WATCH
WORLDWIDE ALLISON TRANSMISSION COMMUNICATION HOTLINE

SUBJECT: New Retarder Lever to Replace Two Previous Levers

MODELS AFFECTED: 3000 Series™ and 4000 Series™ with Retarder

Figure 1. Assembled View
Current P/N 29570374, Top; Former P/N 29522721, Bottom

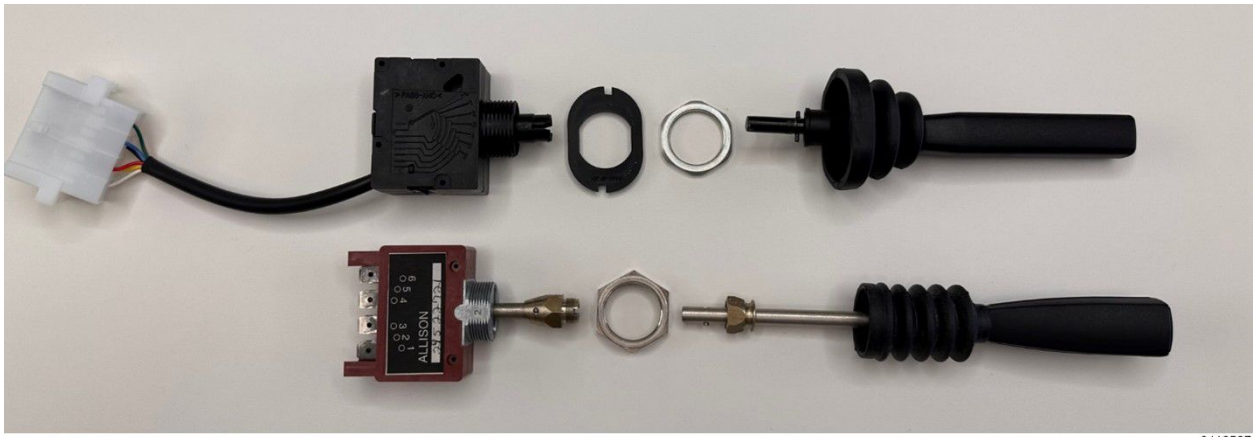
- Inventory available
- This is the current part that replaces both former retarder levers
- Updated design:
  - Press fit lever to module assembly (refer to Figure 1 and Figure 2)
  - Connector included in pigtail (same connector as previous levers)
  - Mounting hole remains same as former
  - Lever positions remain same as former
